## URBAN RENEWAL AGENCY AGENDA

<b>Meeting Date: August 1, 2022</b>		<b>Subject: URA Resolution No. 327</b> Authorizing the City Manager to Execute a Second Amendment to the Construction Contract with Moore Excavation Inc. for the 5 <sup>th</sup> Street / Kinsman Road Extension Project (Capital Improvement Project No. 1139, 2099, 4196, 4215, & 9155)  <b>Staff Member:</b> Zachary J. Weigel, P.E. City Engineer  <b>Department:</b> Community Development	
<b>Action Required</b>		<b>Advisory Board/Commission Recommendation</b>	
<input checked="" type="checkbox"/> Motion <input type="checkbox"/> Public Hearing Date: <input checked="" type="checkbox"/> Resolution <input type="checkbox"/> Information or Direction <input type="checkbox"/> Information Only <input type="checkbox"/> Board Direction <input checked="" type="checkbox"/> Consent Agenda		<input type="checkbox"/> Approval <input type="checkbox"/> Denial <input type="checkbox"/> None Forwarded <input checked="" type="checkbox"/> Not Applicable  <b>Comments:</b> N/A

**Exhibit A - Change Order #02  
Pay Item Adjustment**

## Exhibit B – Change Order #02 Pay Item Detailed Description

**SW 5TH ST TO SW KINSMAN RD EXTENSION  
 COFFEE LAKE CREEK (5TH ST) BRIDGE  
 PLAN AND ELEVATION**

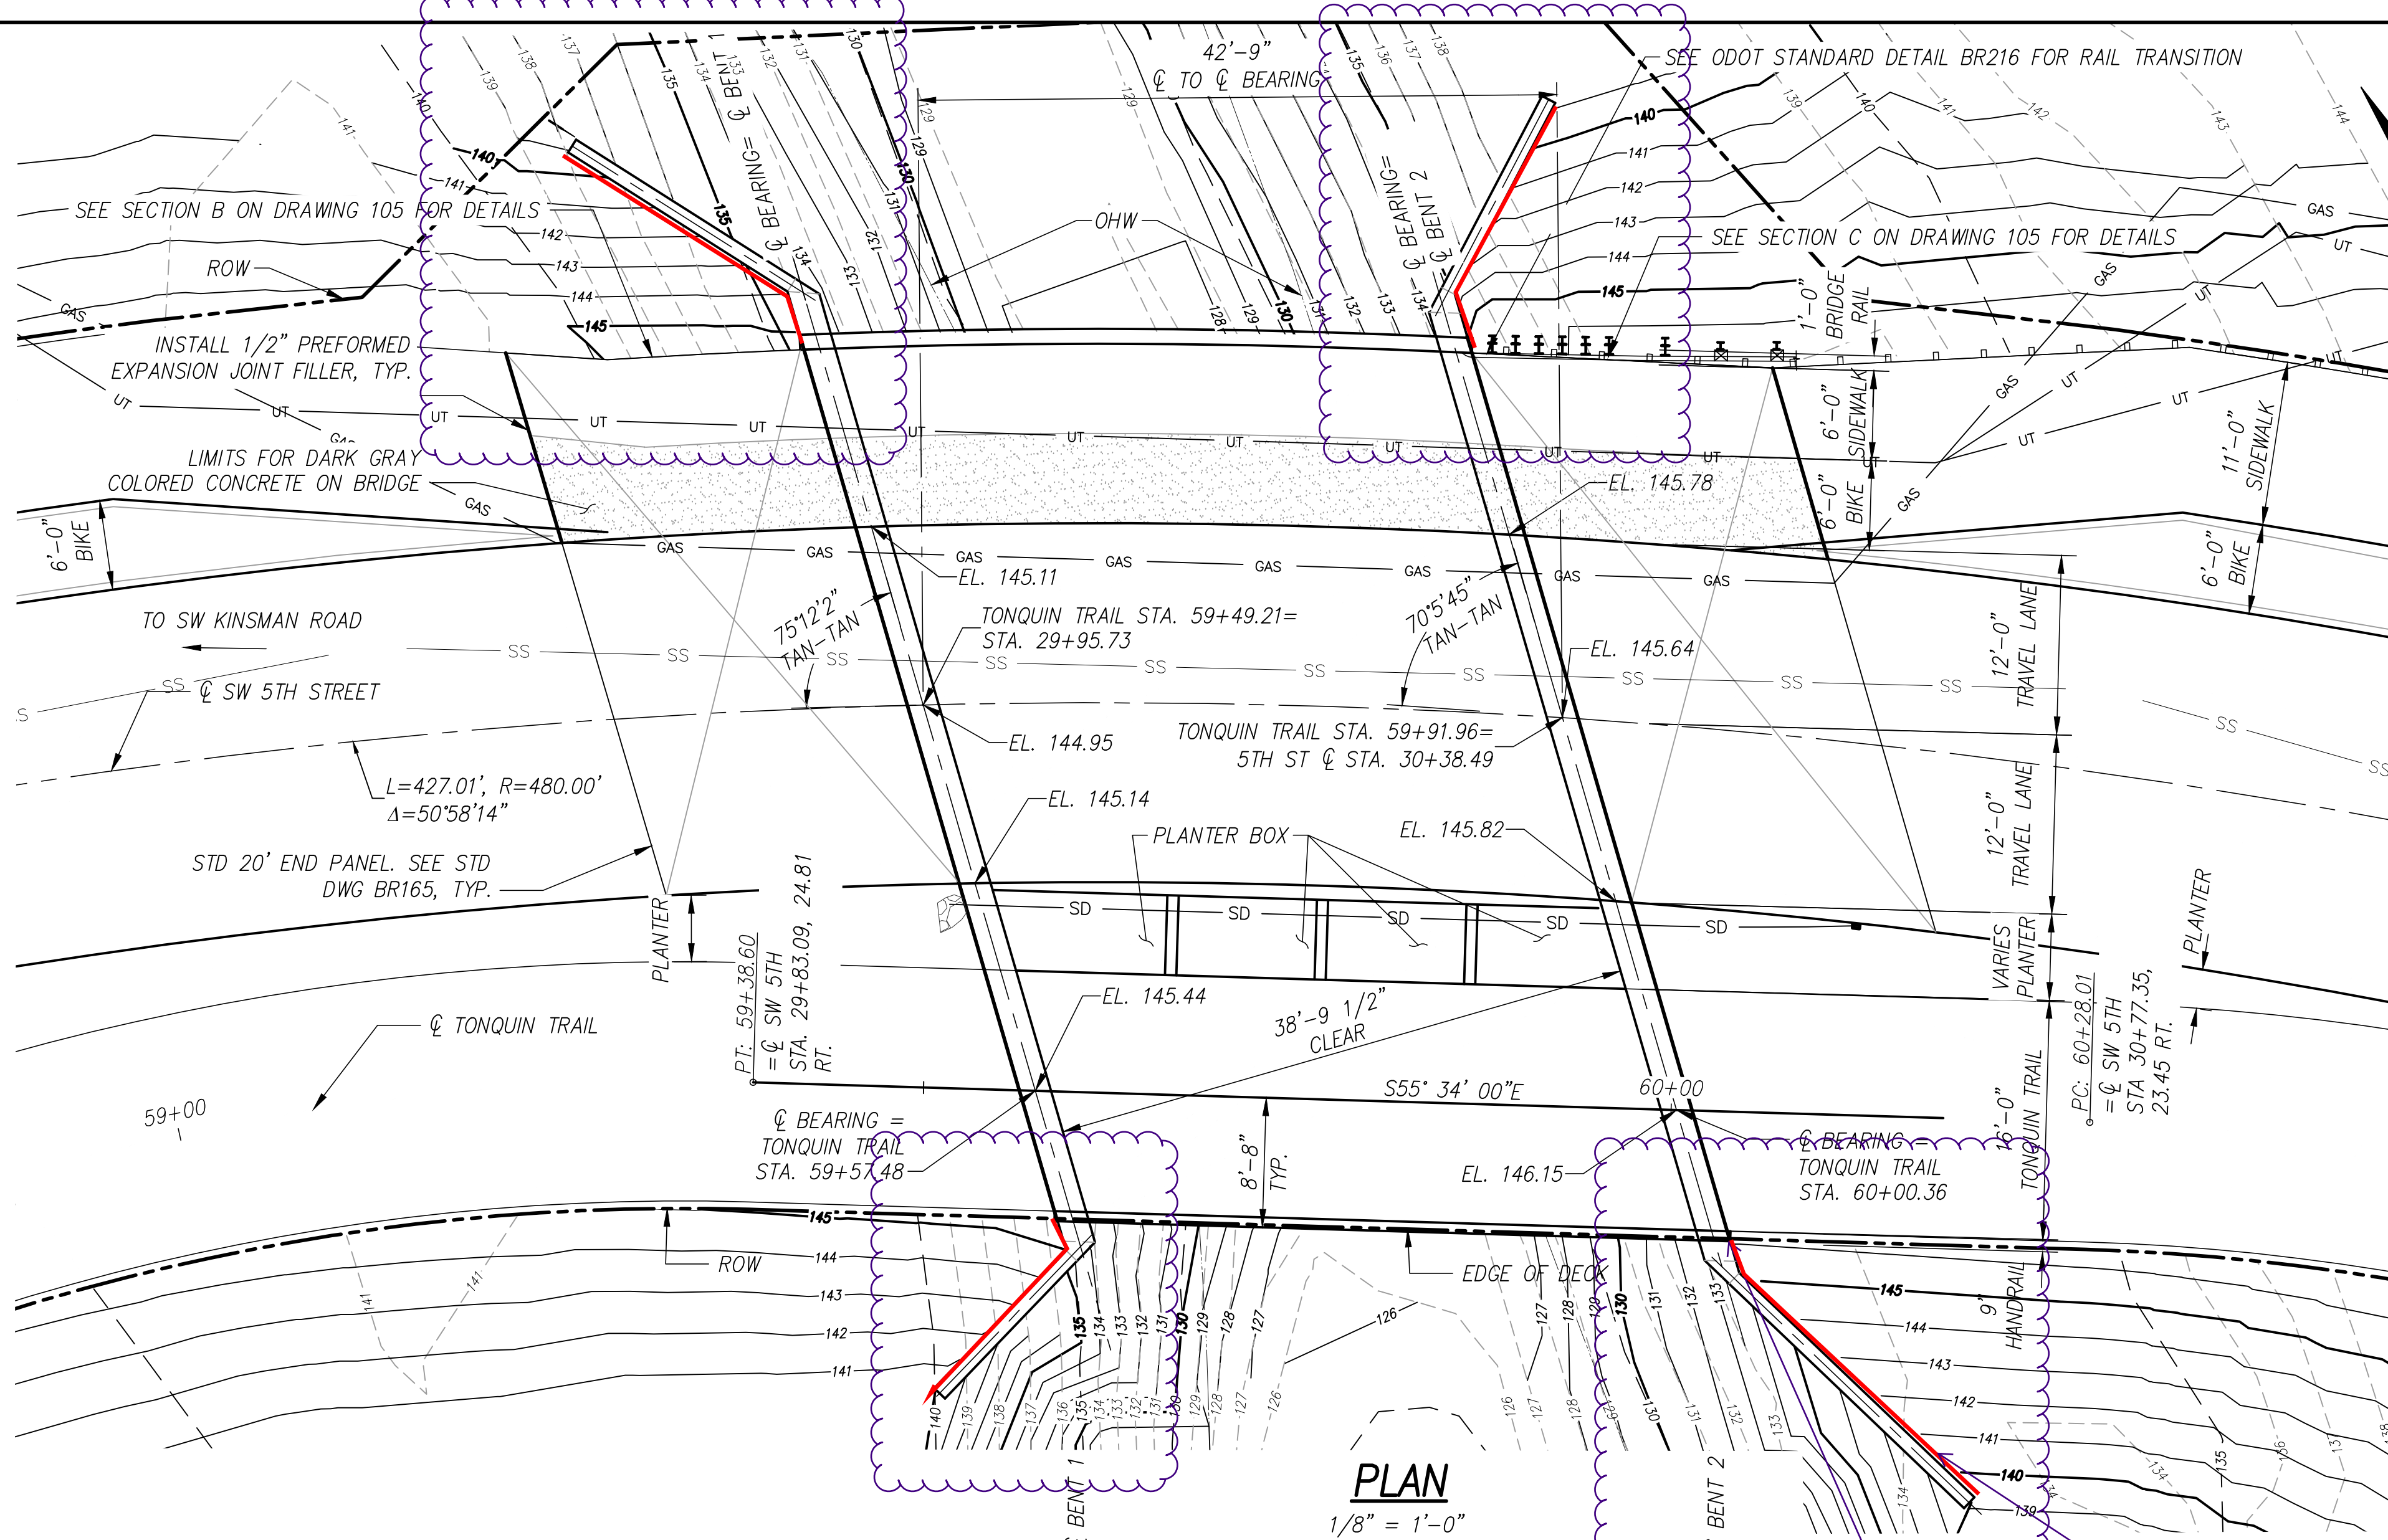
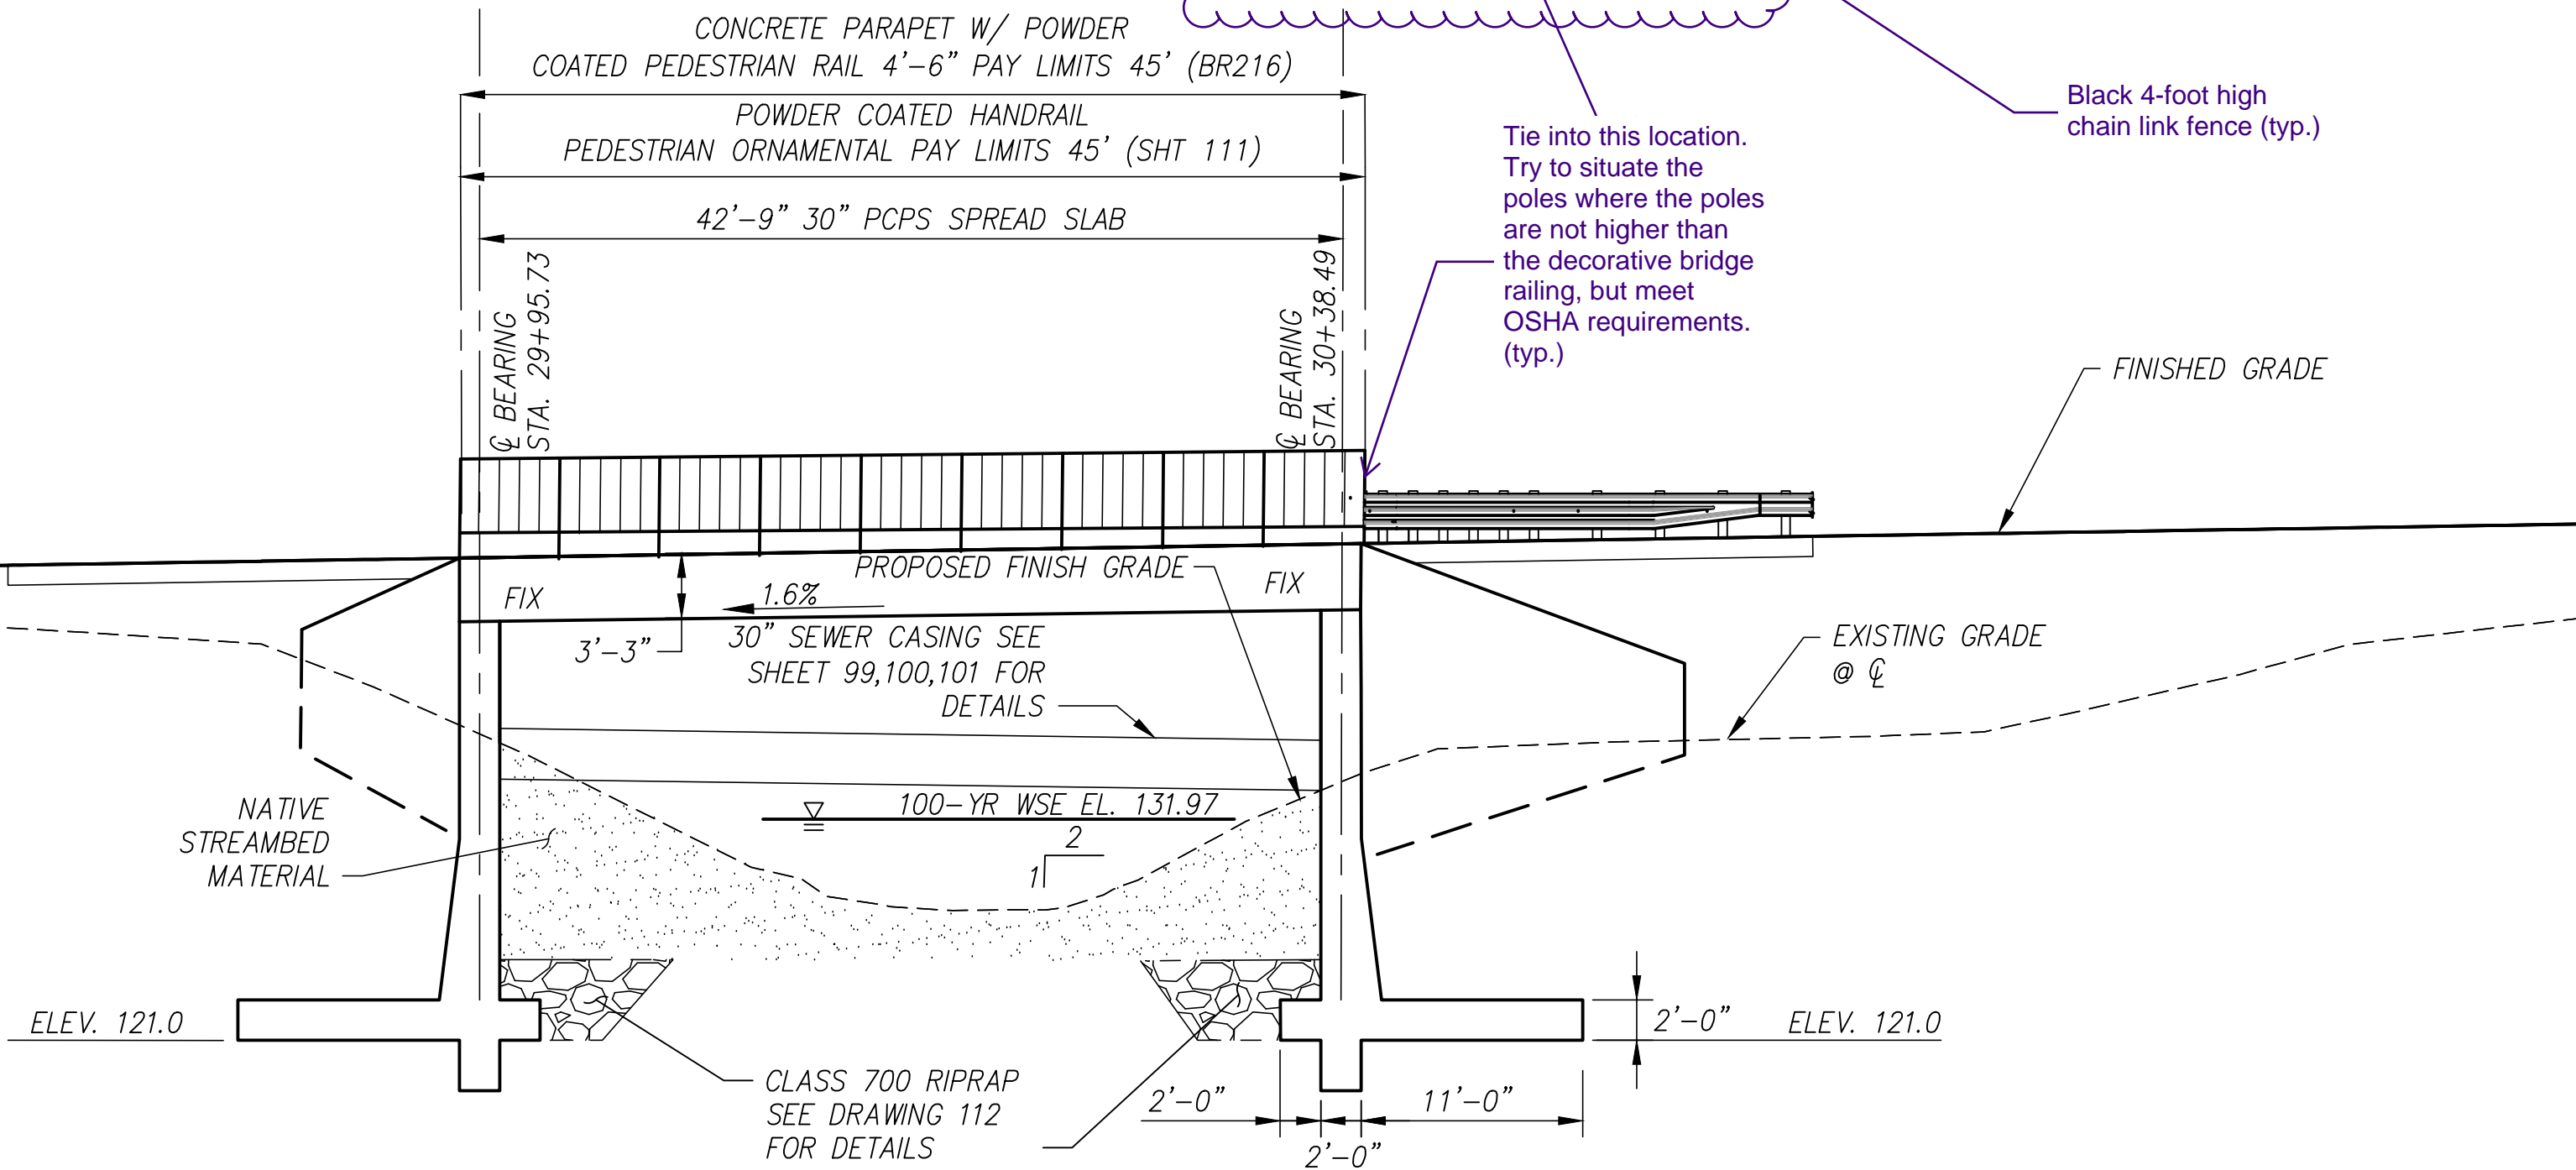
Contractor raised a safety concern with the design engineer regarding a potential fall hazard where the sidewalk is adjacent to the bridge wing wall. There is an elevation difference of up to 4 feet between the top of the bridge wing wall and the adjacent Coffee Lake Creek with no barrier provided between the sidewalk and bridge wing wall. The City and design engineer agreed with the Contractor's safety concern and proposes installation of a 4-foot high, black, vinyl coated, chain link fence for each wing wall on both the 5<sup>th</sup> Street Bridge and Kinsman Road Bridge as documented in RFI 080 (p. 29-32 of Exhibit C).

The Bridge Wing Wall Fence pay item shall include all costs for materials, equipment, and labor to construct the fencing as directed in RFI 080 (p. 29-32 of Exhibit C) and Section 01050 of the 2018 Oregon Standard Specifications for Construction. This pay item will not be measured in the field and will be paid on a lump sum basis at the Contract price.
